Westfield Planning Commission and the Westfield Zoning Board of Adjustment Public Hearing December 28, 2020 to January 11, 2021 to January 25, 2021 to February 1, 2021 6:00 pm – via Zoom

Welcome and opening remarks: Pat welcomed everyone to the hearing and described the meeting as a public hearing to consider application number 2020-18 by Horizons Engineering on behalf of Mark and Marielle Demuth to subdivide property into 4 lots, three 3-acre lots and one 4.3 acre lot where a 40'x80' warehouse storage building and access road, and gravel pad will be constructed. Water and sewer connections are not proposed for the property.

Attachment A:

Attachment B:

2 attachments 20713_ROZELLE SUBDIVISION.pdf 3696K Sub_Cat Drainage 20713_ROZELLE SUBDIVISION.pdf

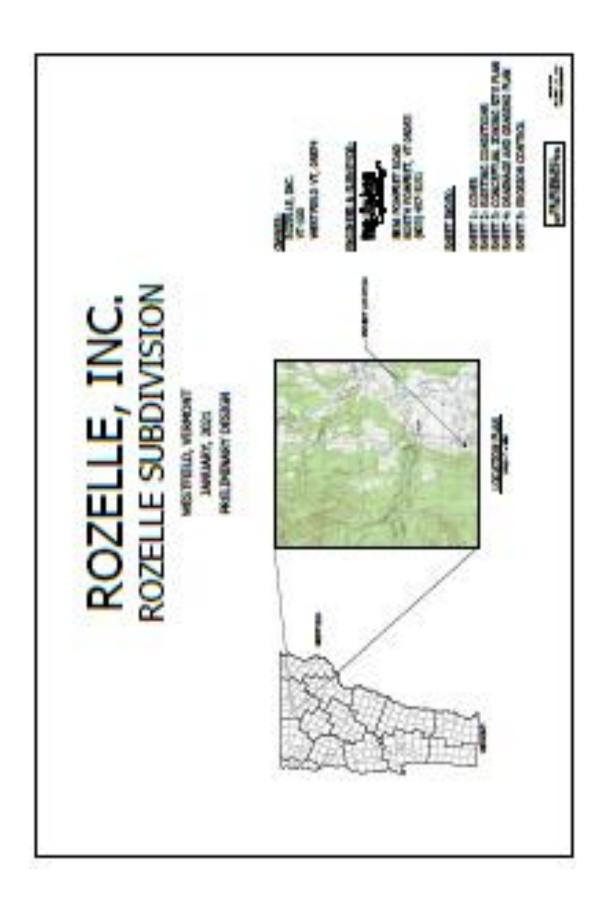
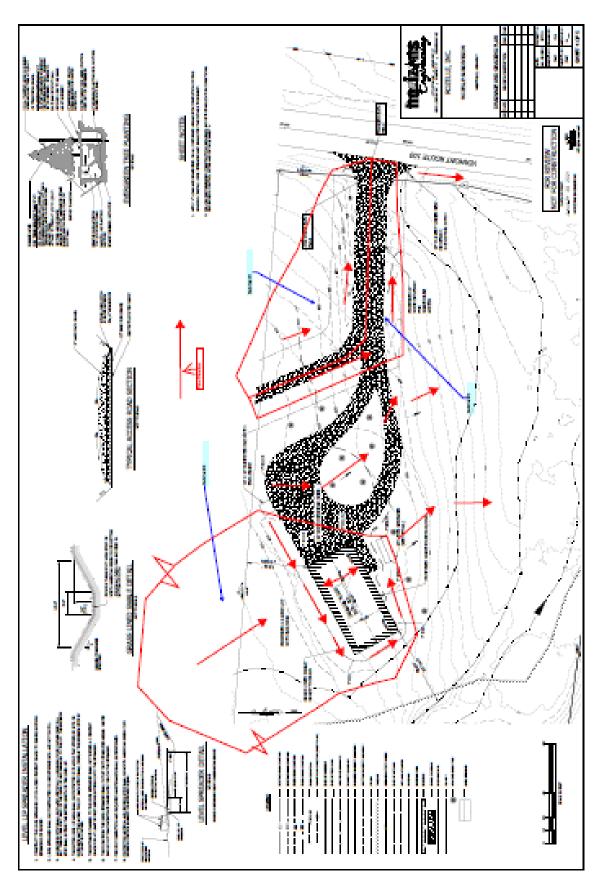
Please find the attached revised drawing set for the Board's review. We have added a grading and drainage sheet in order to better show how the stormwater will work and some detail on the permanent drainage features. Also we added some landscaping in the form of evergreen trees along the south and east. Following is a narrative discussing the overall drainage area and the 3 drainage subcatchments associated with the site. I've included a separate .pdf with approximate site drainage areas and flow direction represented for clarity.

SC#1 – This area drains to the access road ditch along the North side, it is a total of 0.33 Acres (2/3 grass, 1/3 gravel road). During a 10yr design storm the rock-lined ditch will flow ¼ of a foot deep. We have indicated on the plans the ditch is to have 6-inch minus rock in areas in excess of 5% ditch slope, that will be for much of the ditch from Rte. 100 to where it flattens out on top closer to the building.

SC#2 – This area is the other south side road ditch, similarly it is approximately a 1/3 or less of an area with the same proportion of Grass and gravel. Similar flow conditions as the above.

SC#3 – This area drains to the swale on the uphill side of the new warehouse, it picks up the roof and about an 1.5 AC of forest and field, the runoff is intercepted with a swale that gently slopes to the west and around the building effectivity increasing the normal flow path. The flow concentrated in the flat swale will be spread out into sheet flow when it makes it to the 20-foot long level spreader on the south side of the building. At that point it will once again be sheet flow down to the wetland. The swale flows at 1/3 of a foot deep during a 10-year storm.

The remainder of the site is graded such that the gravel will sheet flow to the grassed areas to the south prior to eventually making the wetland and the cross culvert.

One other minor change we made was to move the building 15-feet from the wetland buffer, about another 8-feet, to allow

for construction. A silt fence and orange construction fence will be placed along the wetland buffer in this area during construction.
